NOTICE OF NON-PERFORMANCE

INSPECTION REPORT

Electrical Corporation:	Pacific Gas and Electric Company
Report Number:	PAD_PGE_AXS_20251118_1057
Inspector:	Alexander Scott
WMP Year Inspected:	2025
Quarterly Data Report (QDR) Referenced:	Quarter 2 (Q2)
Inspection Selection:	Energy Safety viewed the contents of the Q2 QDR and performed an analysis that resulted in the selection of the WMP initiatives and locations referenced in this report.
Relevant WMP Initiative(s):	8.1.7.2 - Open Work Orders – Distribution Tags
Date of Inspection:	November 18, 2025
City and/or County of Inspection:	Santa Ynez, Santa Barbara County
Inspection Purpose:	Assess the accuracy of Pacific Gas and Electric Company’s QDR data, completeness of its work, and performance of WMP requirements.

Item1B1Img1-3 Pacific Gas and Electric Company Document number 066209

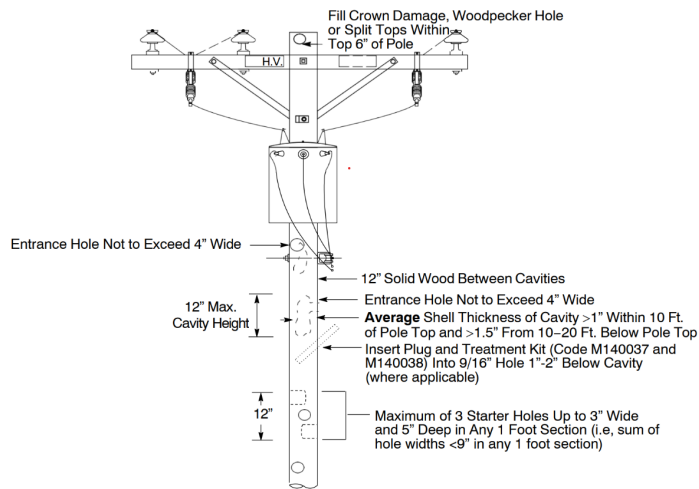
1. PG&E's Field Safety Reassessment (FSR) was completed for a pole that was originally determined to need replacement, and the FSR deemed the scheduled replacement to be unnecessary.
2. The inspector observed decay at the pole top from ground level.
3. The inspector observed a large mass of the pole missing within 6" of pole top, and near a span guy wire, which warrants pole replacement per PG&E document TD-2305M-JA02.
